# SAFETY RECALL BULLETIN

## NHTSA RECALL 12V-046

AUTOCAR, LLC SAFETY RECALL A-1201

Temporary Fix to Bendix ATR-6 Valve

**FIGURE 1 - BENDIX® ATR-6™ TRACTION RELAY VALVE**

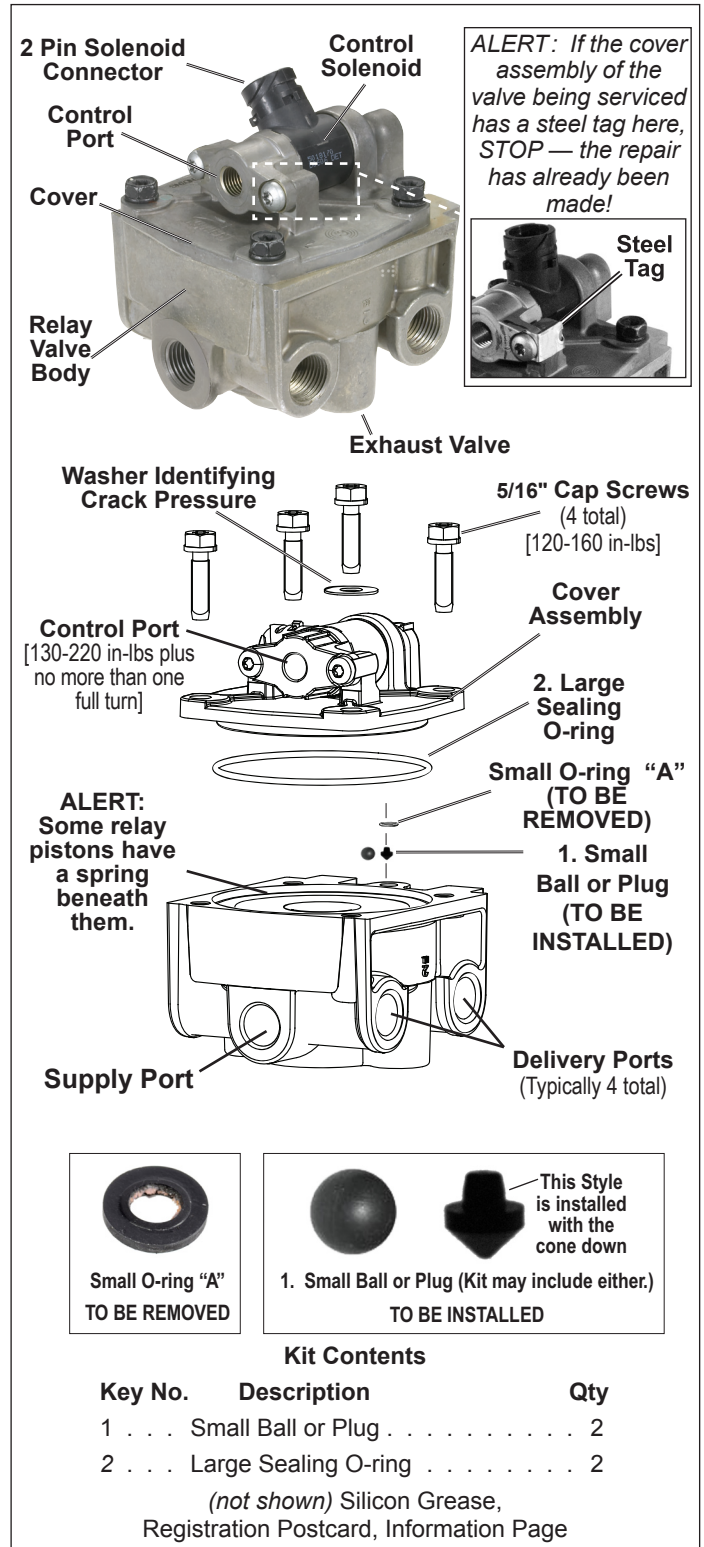
6. **Remove and discard** the small O-ring ("A" in Figure 1) and the large sealing O-ring (2) from the cover.
7. Grease and install the new large sealing O-ring (2) onto the cover assembly.

8. Grease and install the supplied ball or plug (1) into the valve body where the small O-ring was removed, so that it blocks the air passage. Plugs are installed with the cone down.
